Horowhenua County Council

PERMIT No. 15880
C024145LOCALITY Waikanae

APPLICATION FOR BUILDING PERMIT

Particulars of Building: Foundations: concrete Walls: timber Roof: tileTotal floor area: 231 m² 237 sq. metres. front = 16.6 1st = 7.2 (garage = 3.6)2. Purpose for which every part of Building is to be used or occupied. (Describing separately each part intended for use or occupation for a separate purpose) Garage room, double garage, 3 bedrooms, living room, dining room, family room, kitchen, bathroom3. Allotment: 460 m²Lot: 2D.P.: 55 724Section: 35-663Area: 460 m²Block: WALKWAYS.D. WALKWAYLocality: Edge water ST4. Owner's Full Name: NICHOLAS HENRY BRANLEYAddress: P.O. Box 365 Parua

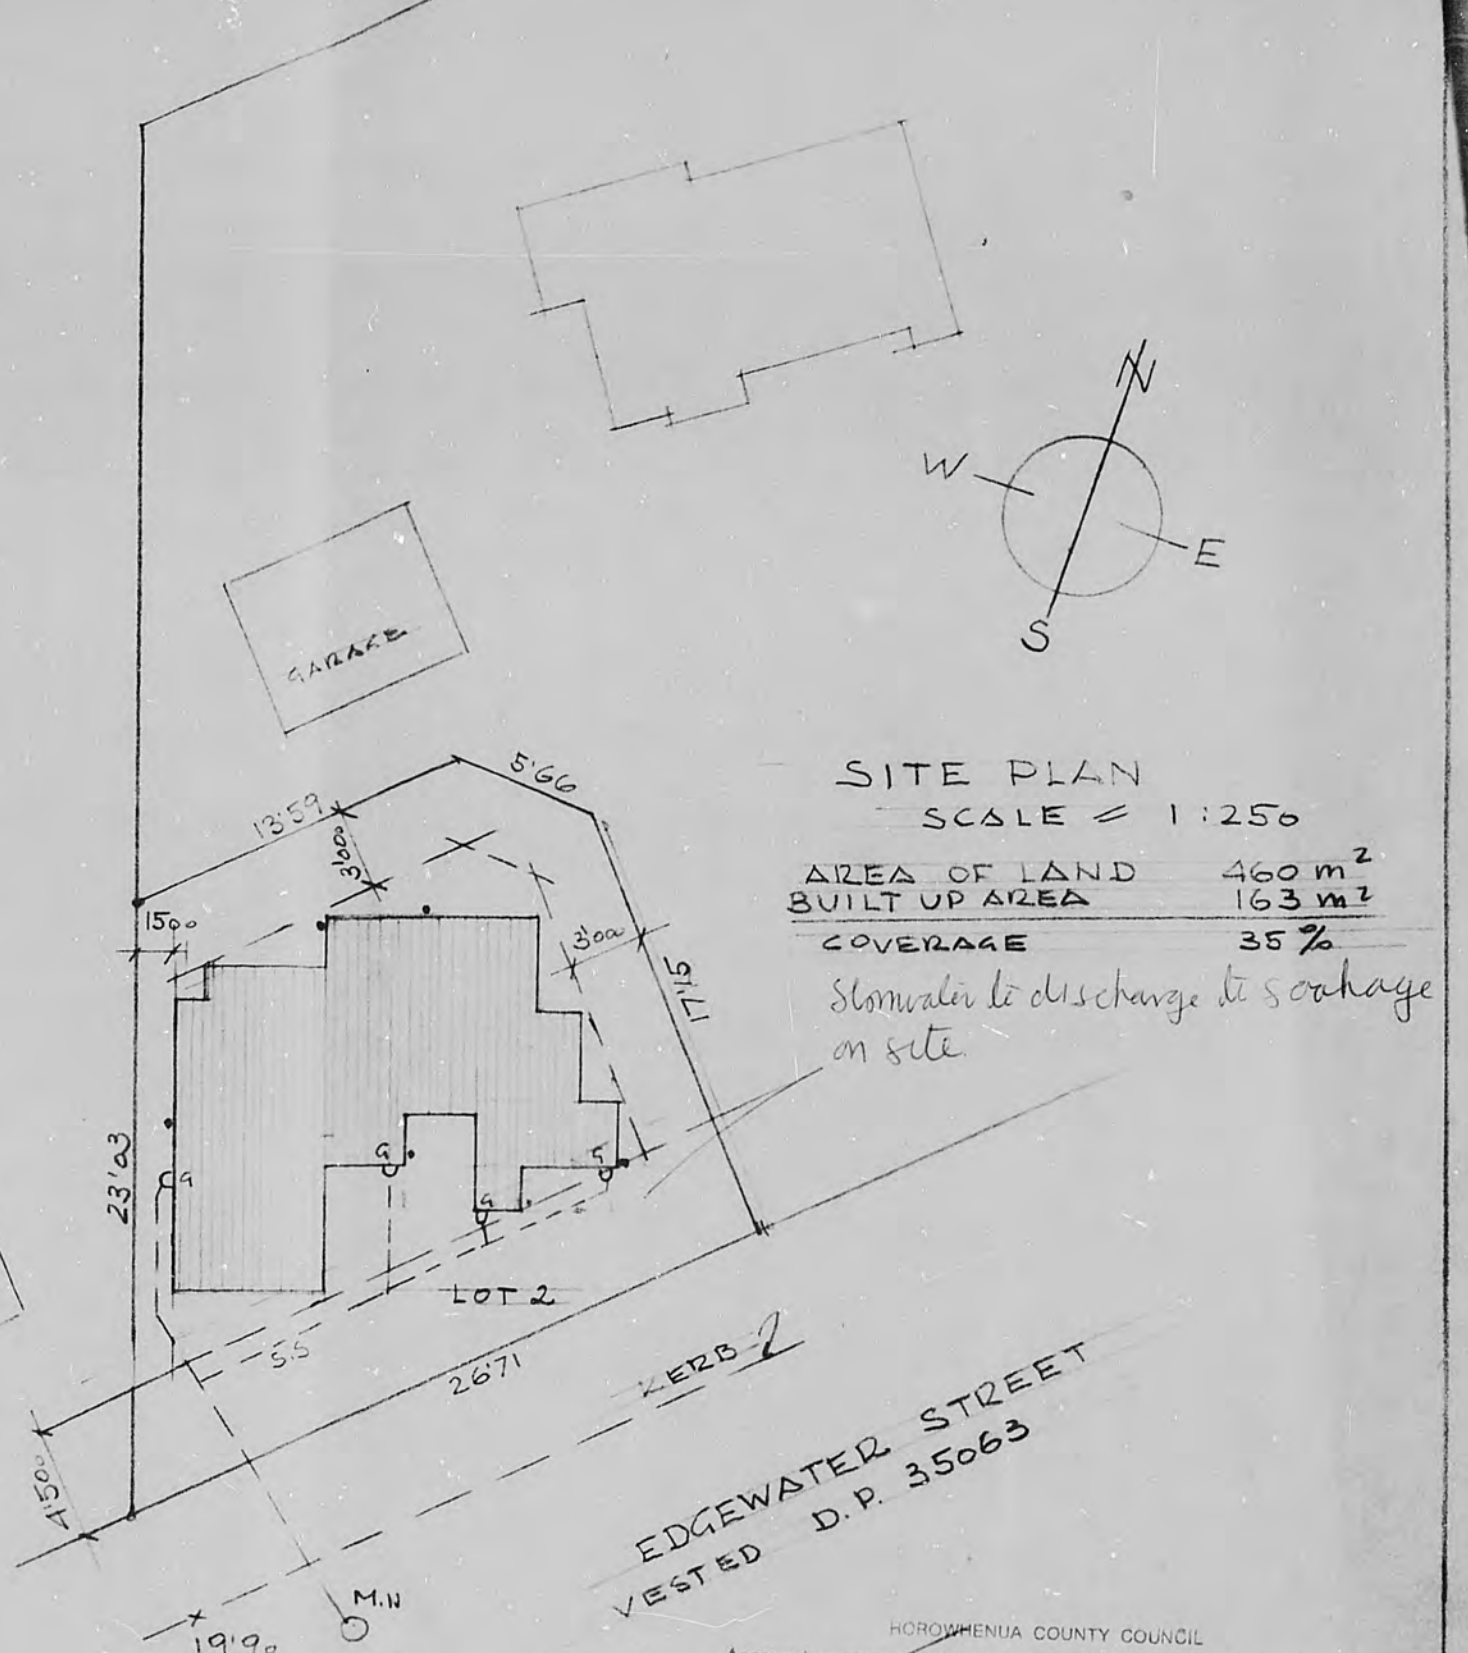
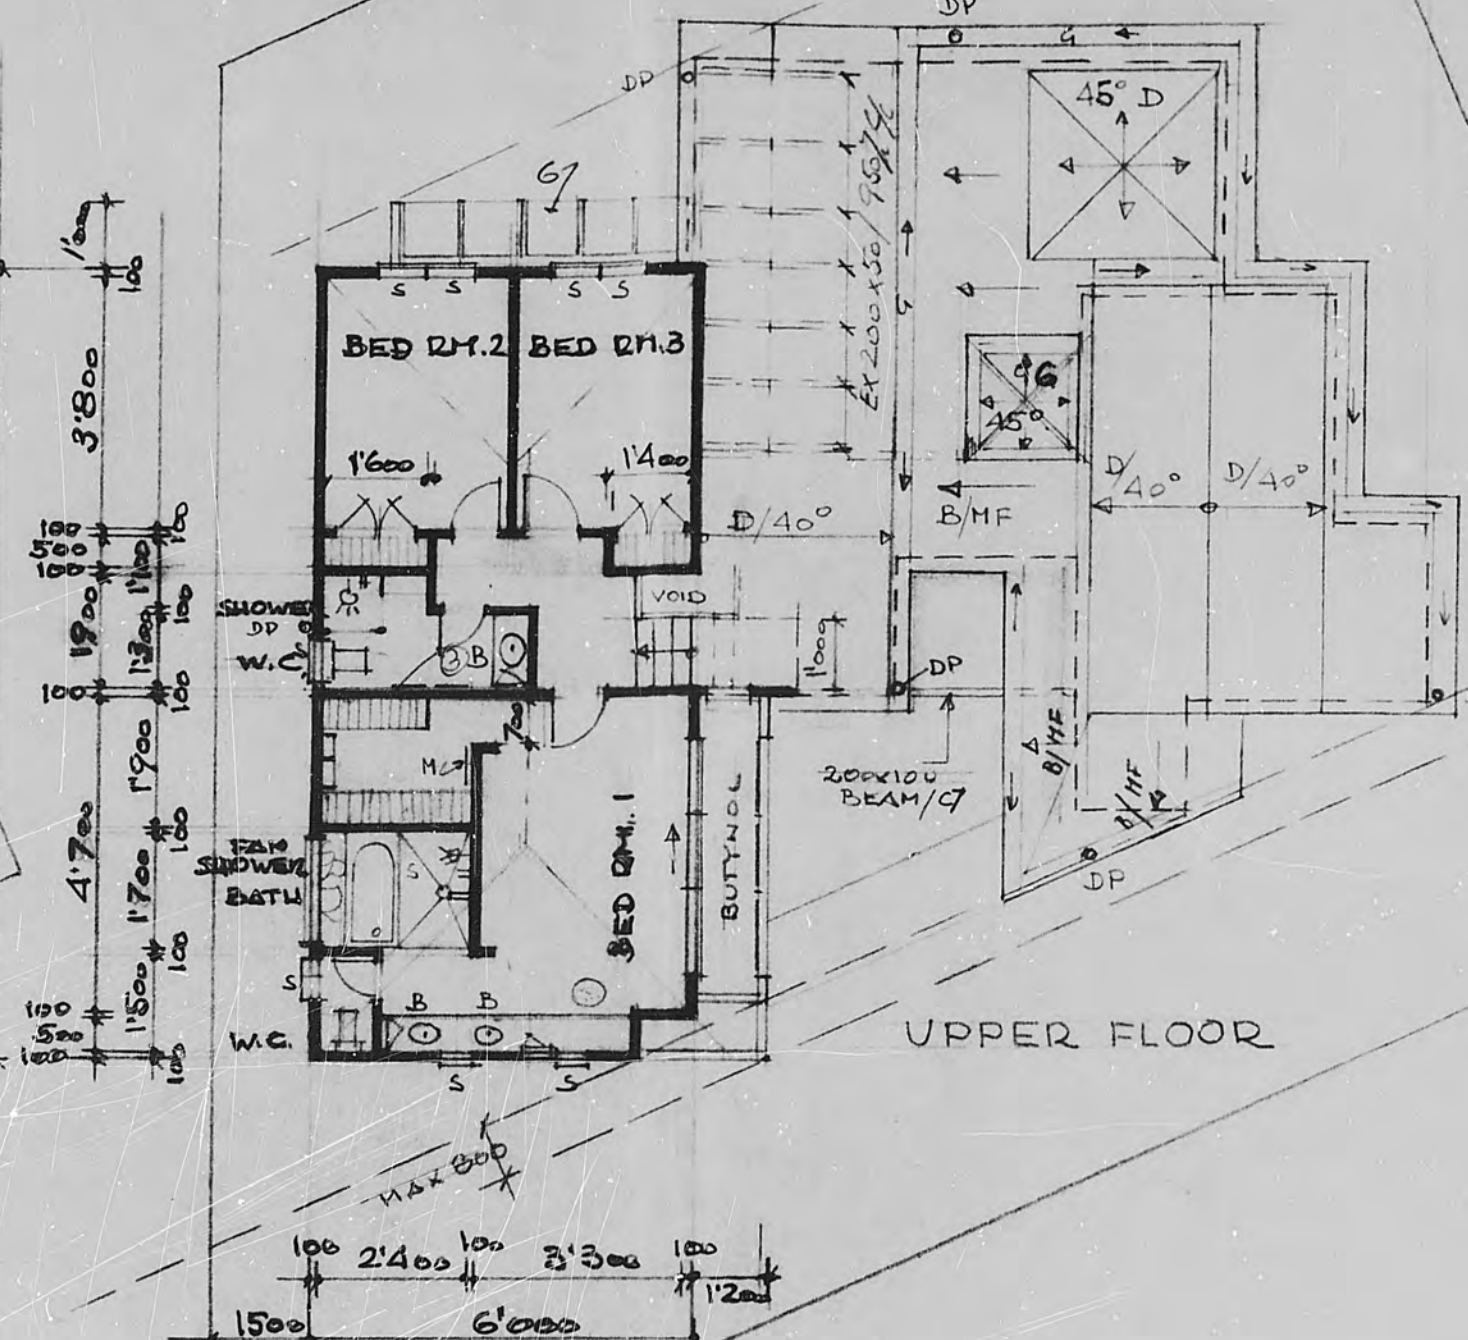
Notes:
 ① The common garage wall both sides must be insulated as per external walls.
 ② Where external steelwork (girders) occur over bracing elements they shall be fixed as steel material over a brace (ie 150x400 or 150x300 as appropriate).
 ③ Where bracing elements occur behind prefabricated linings the element including steel (material forming part) shall be insulated before fitting prefabricated lining.
